Emon Fashion Ltd. (New Unit)

42, Mariyali, Joydebpur, Gazipur.

16th July 2019

Location of separation in column layout drawing

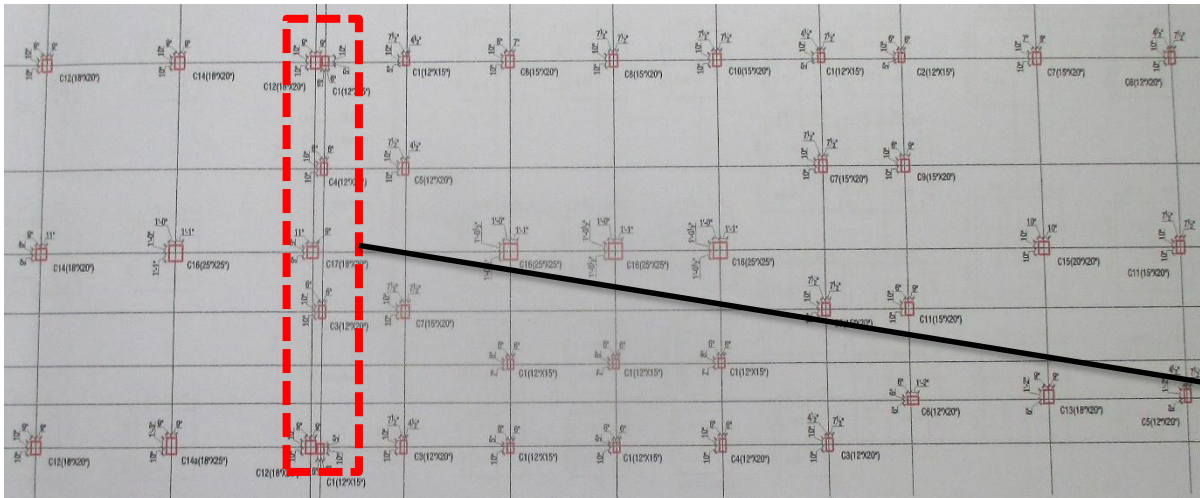
Outline between the building does not have adequate clearance

The building is analyzed in two parts, but on-site clear gap was not observed. Building Engineer is required to ensure whether the structures are separated or structurally connected. If separated, then adequate gap is required to be provided for movement and seismic provision. If the structures are connected, then factory is required to carryout analysis of the building considering a single structure.

Slenderness effect of internal columns not addressed in design report

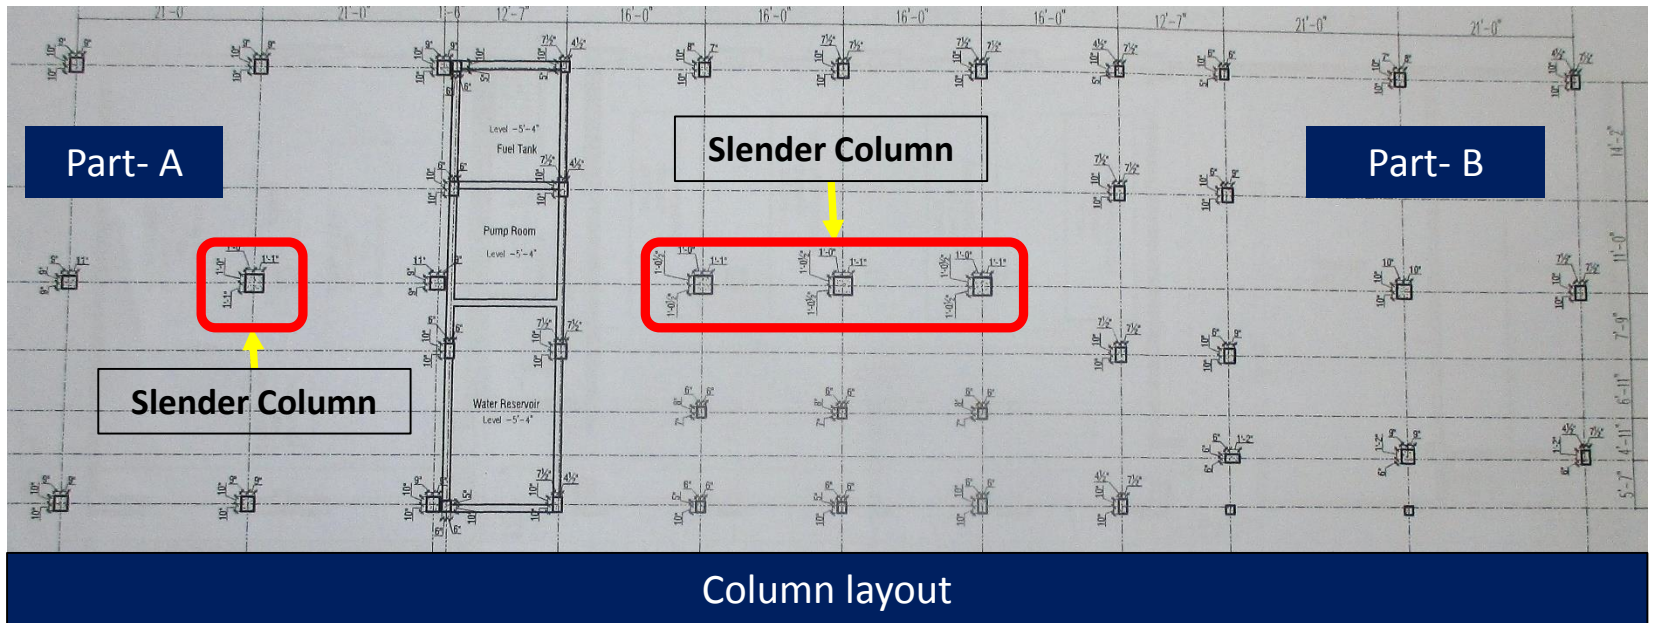
There is no tie beam for internal grids. Tie beams exist only in peripheral grids. Slenderness effect may act on the internal columns. Also, in design report slenderness effect of columns was not addressed. Factory engineer is required to check the slenderness effect of those columns.
